ADDENDUM NO. 1

CSP# 207702

**Org # 194 – K.B. Polk Center for Academically Talented & Gifted -
Renovation**

20 December 2024

SHEET NUMBER
 E5.04

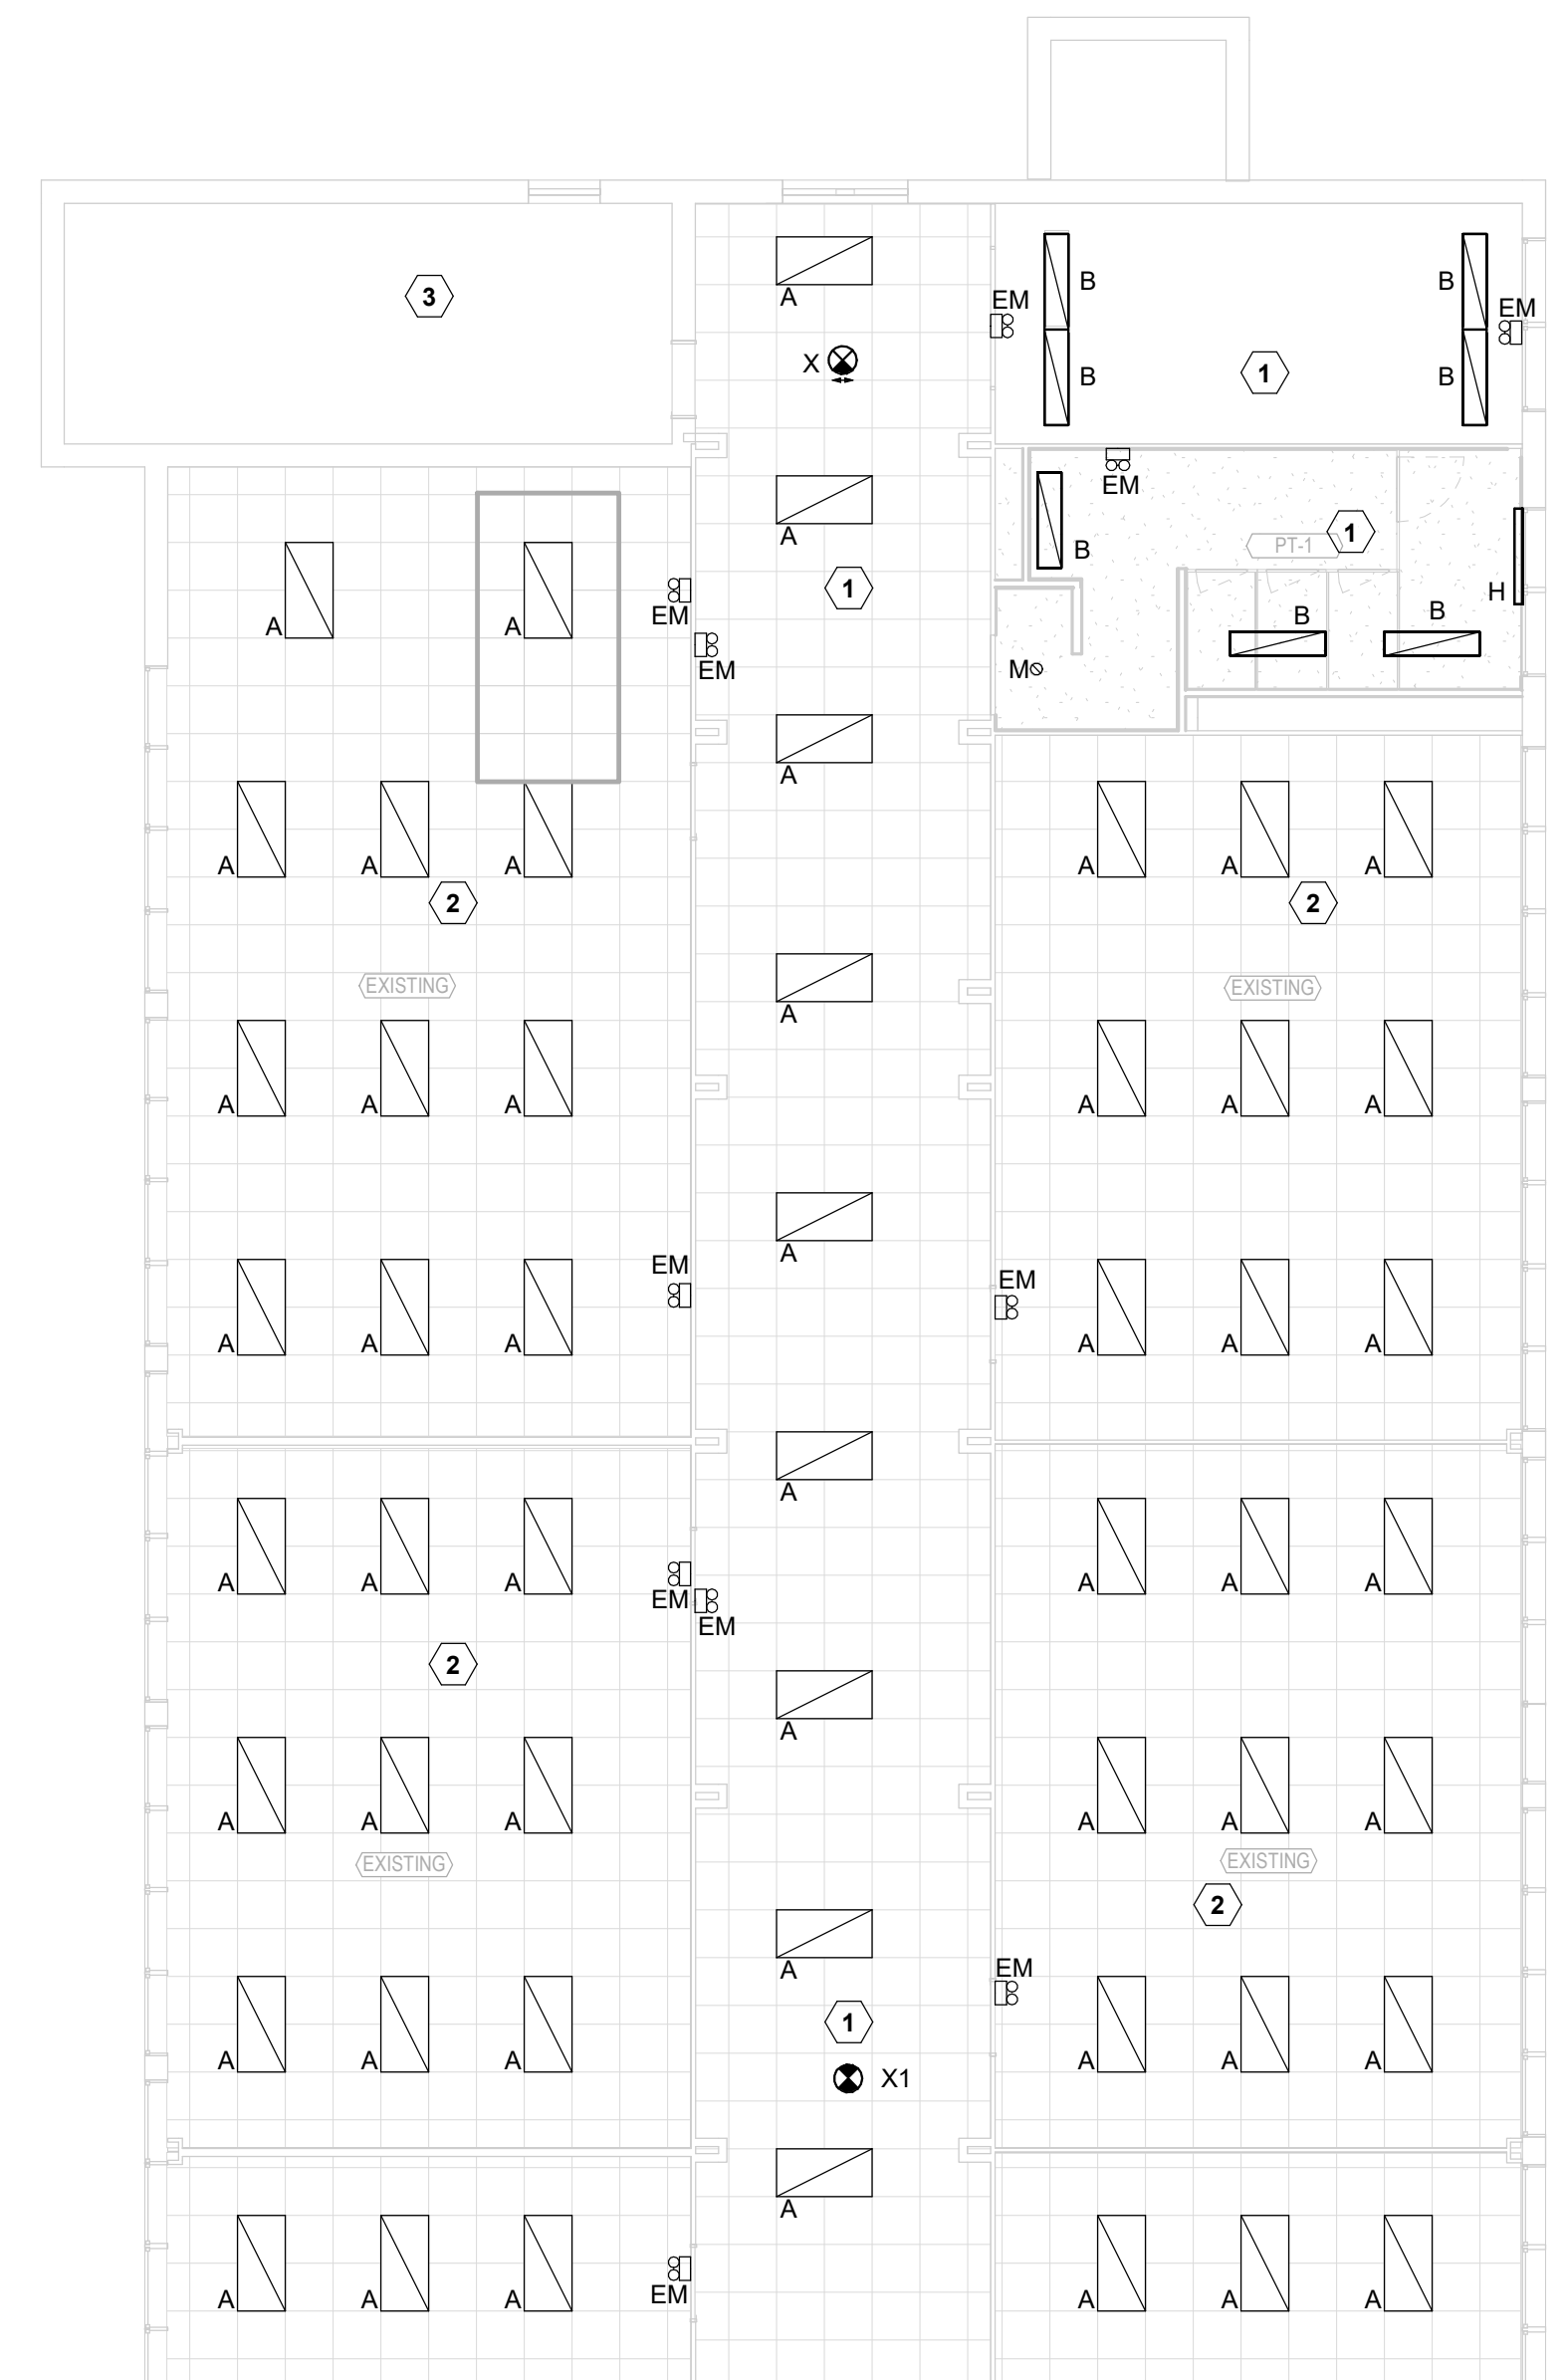
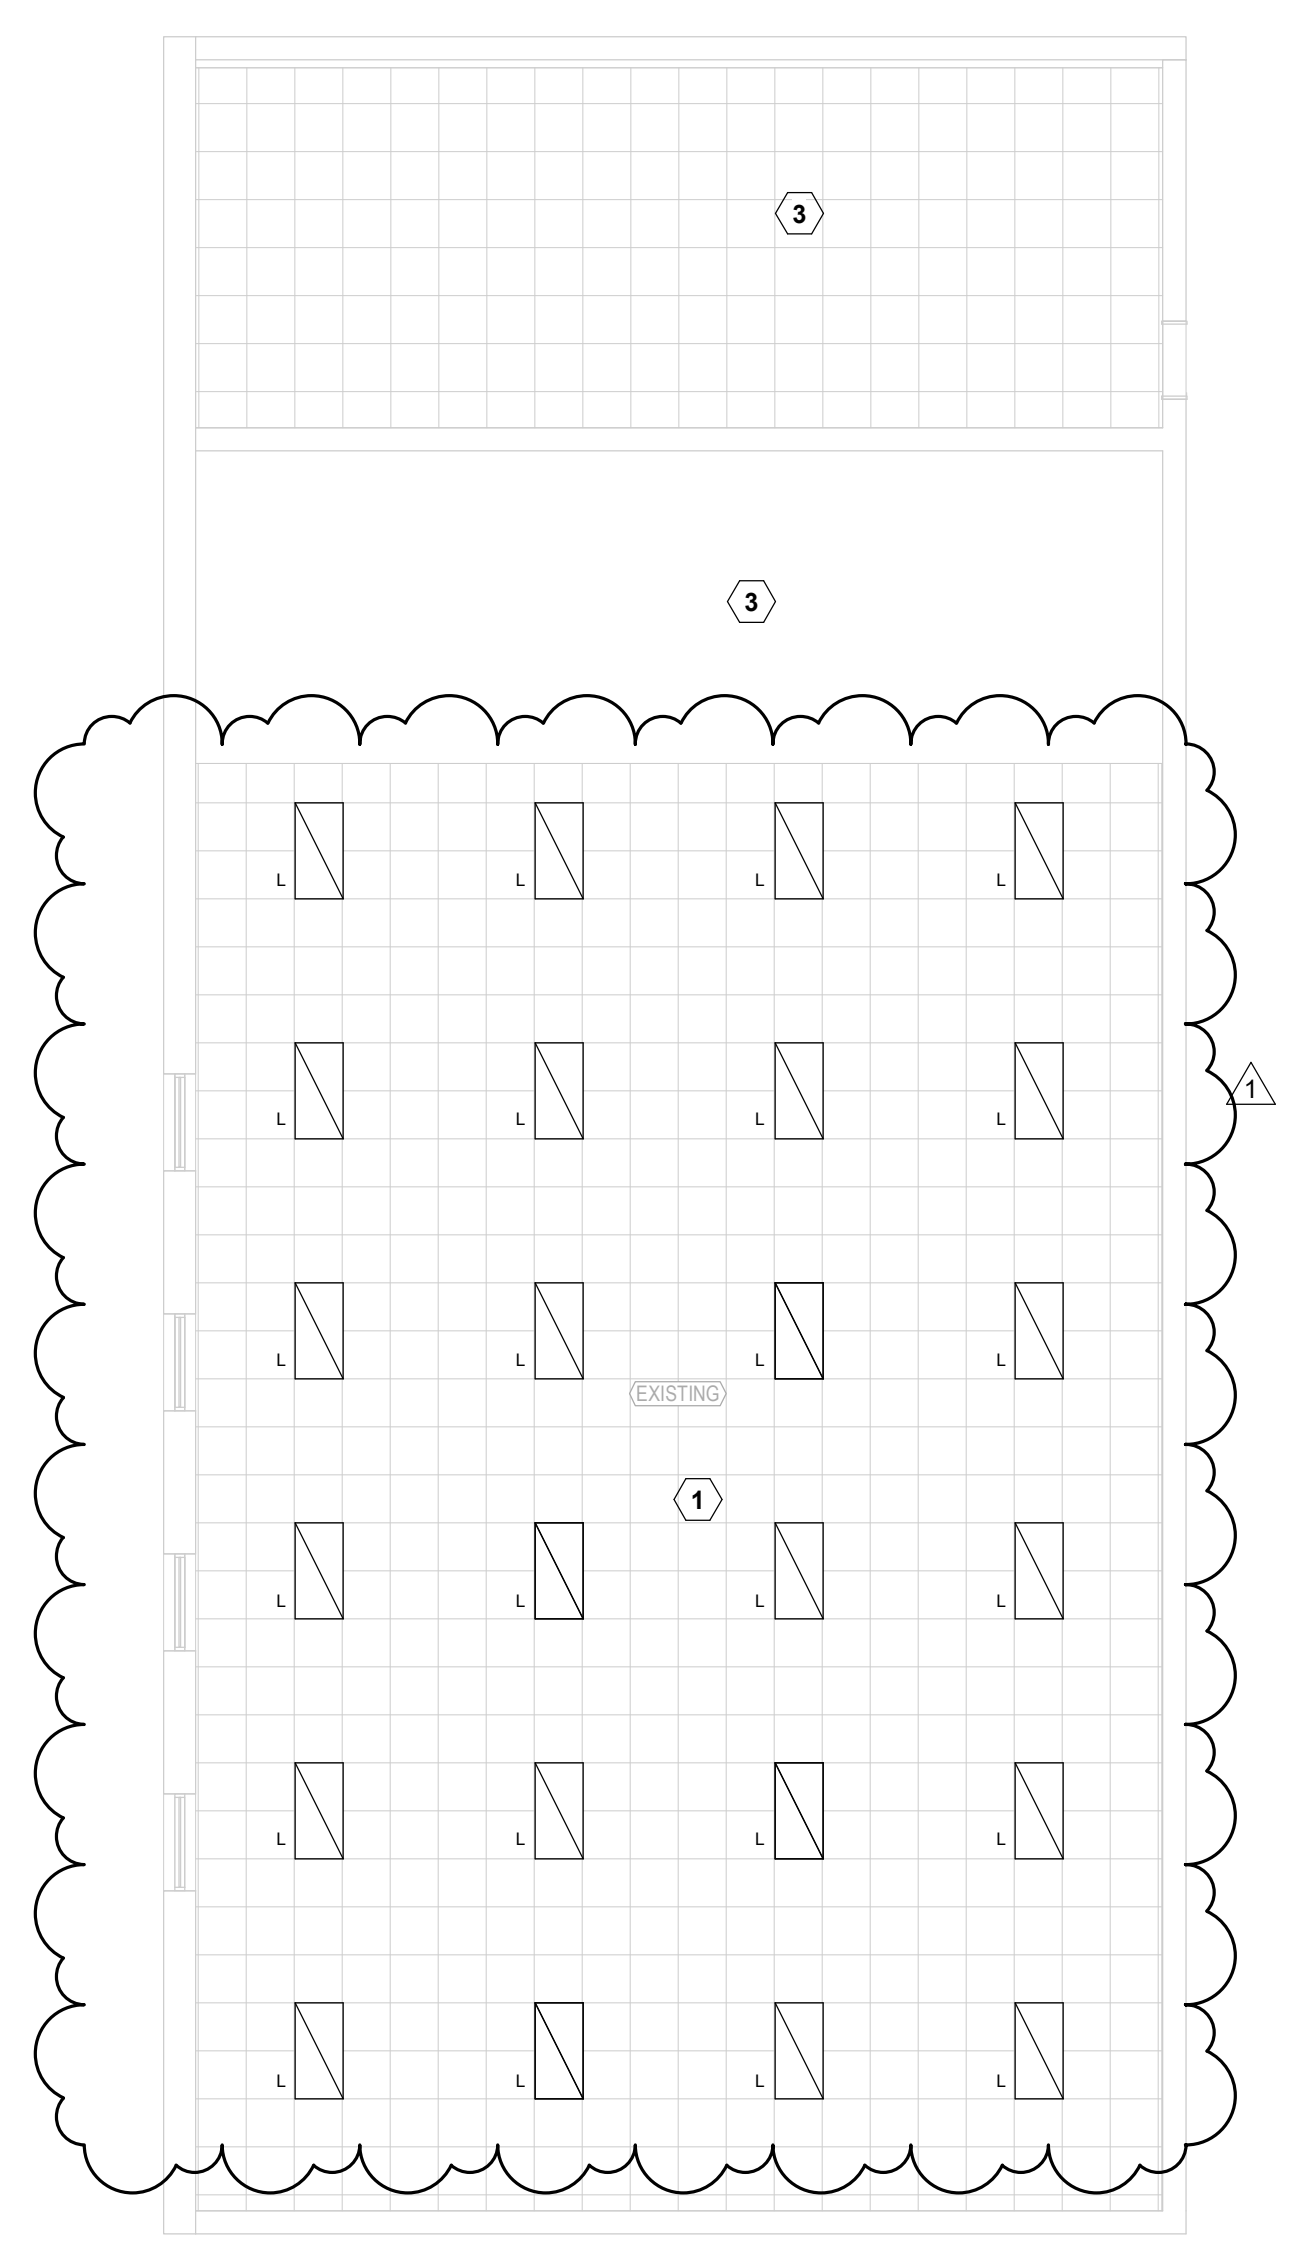
- **Sheet E5.04 – Replace sheet with the revised attached E5.04 LEVEL 1 LIGHTING PLAN B**
 - Revised sheet notes and scope per attached sheet.
- **Sheet E6.03 - Replace sheet with the revised attached E6.03 LEVEL 1 LIGHTING CONTROLS PLAN B**

SHEET NUMBER
E6.03

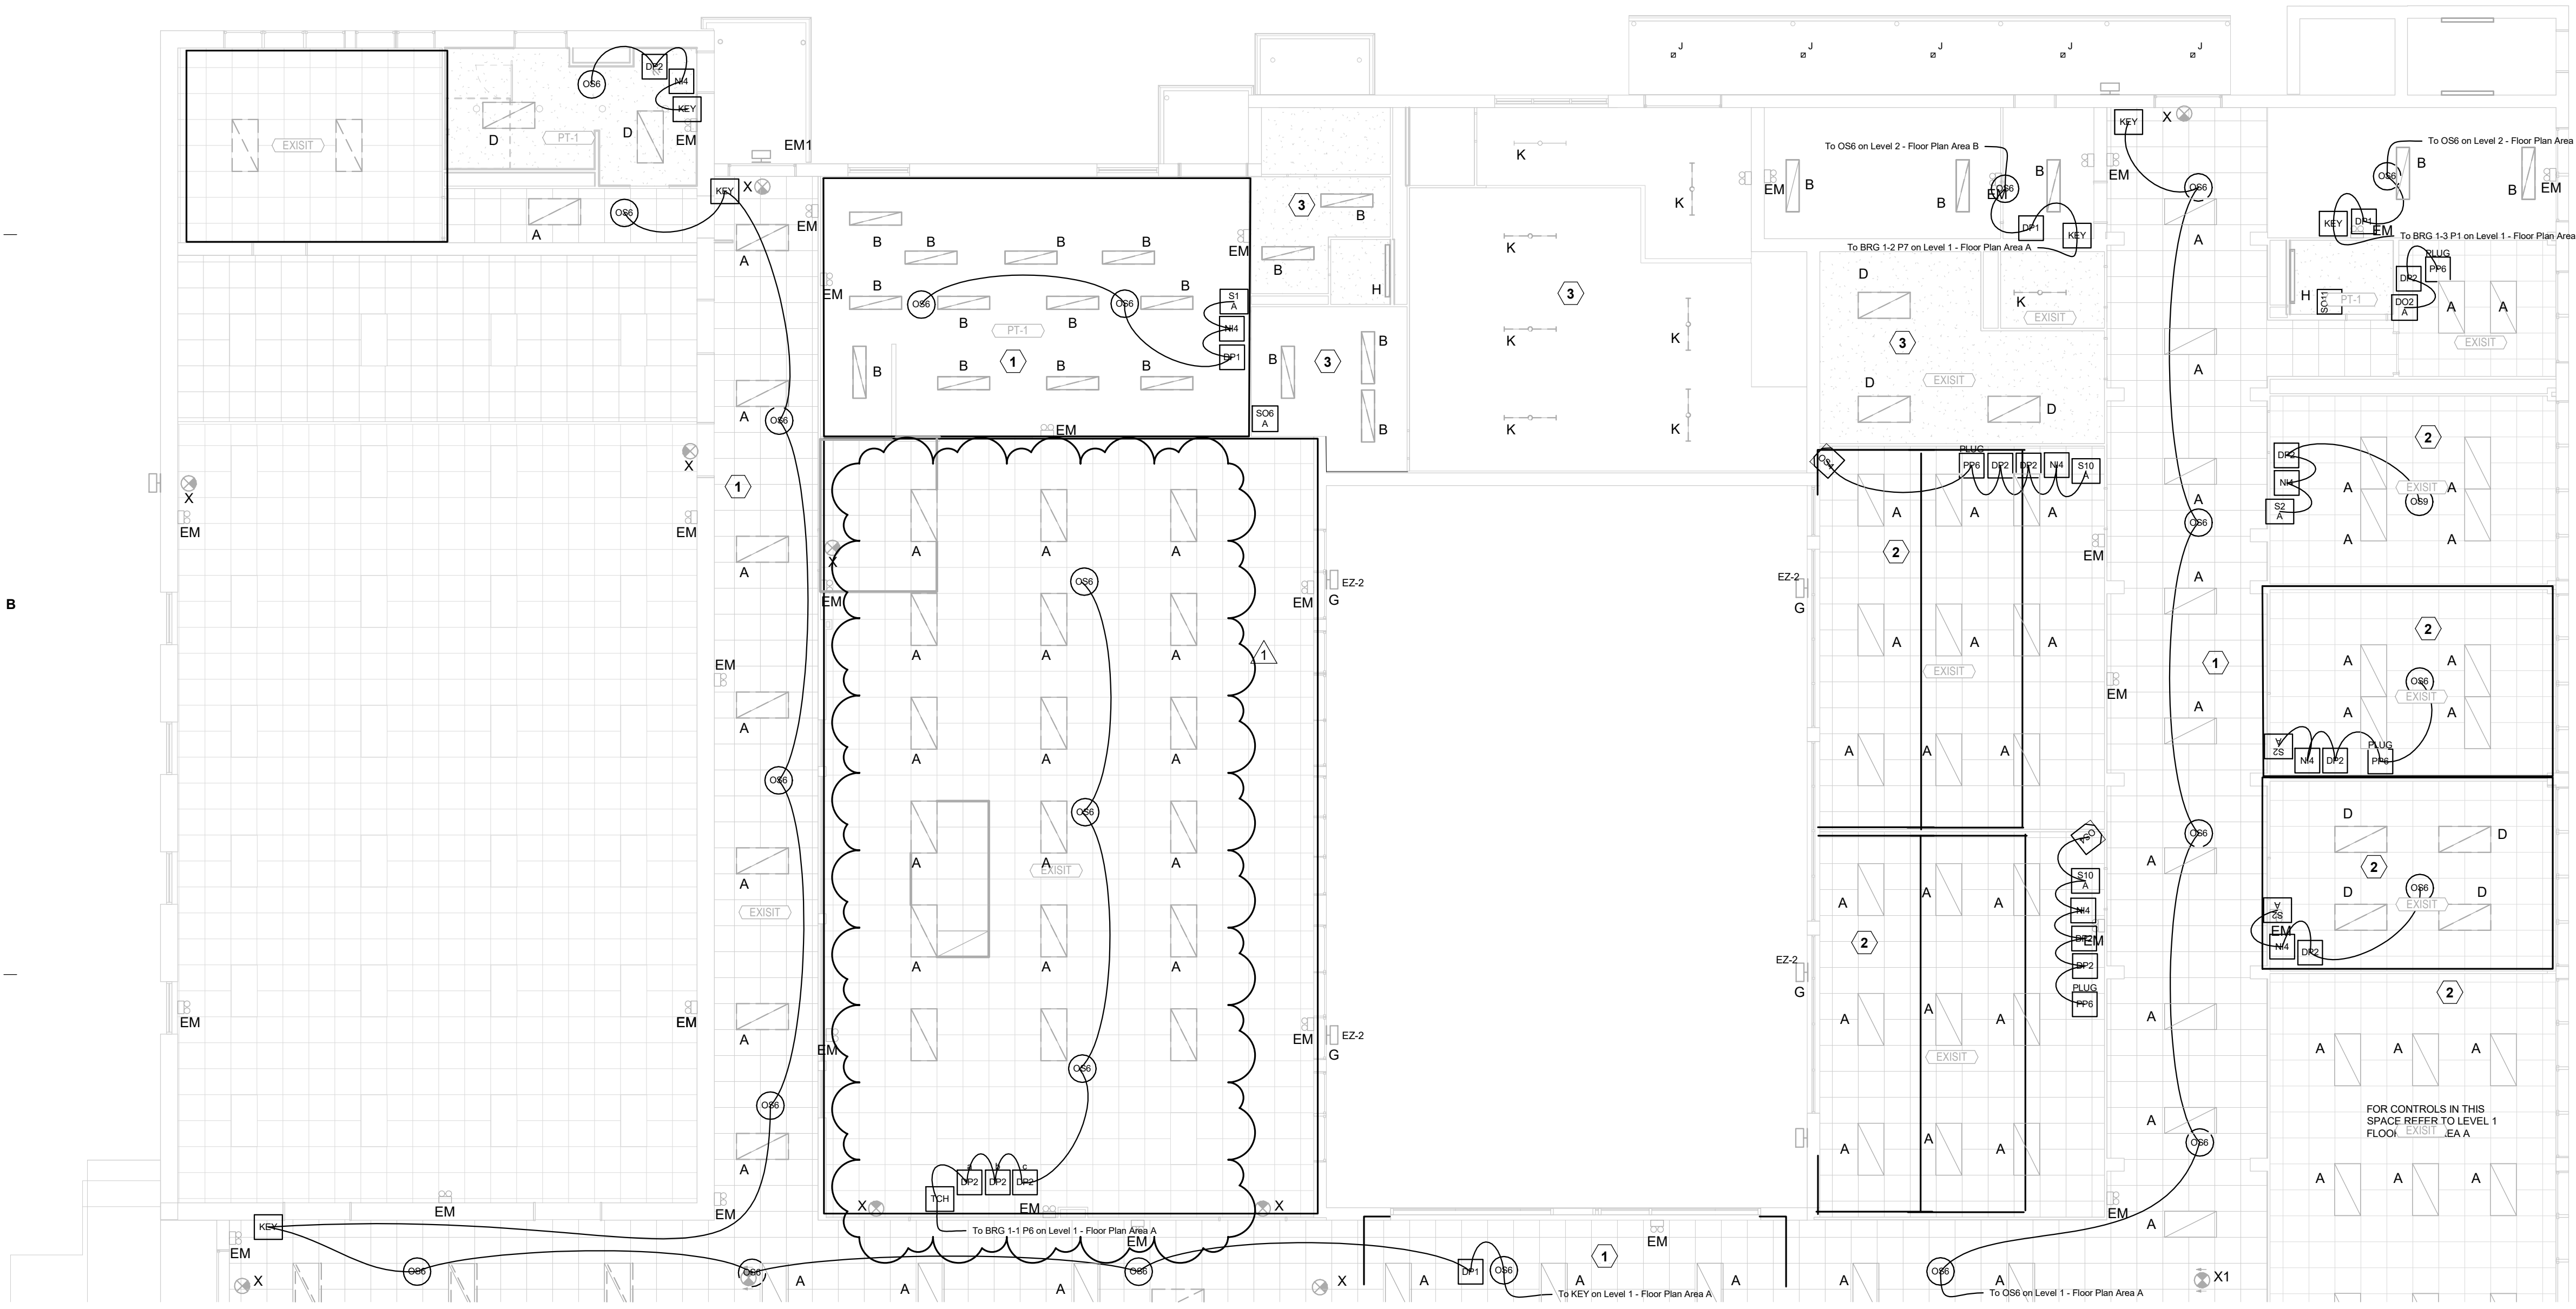
- Revised sheet notes and scope per attached sheet.
- **Sheet E6.04 – Replace sheet with the revised attached E6.04 LEVEL 2 LIGHTING CONTROLS PLAN A**
 - Revised sheet notes and scope per attached sheet.
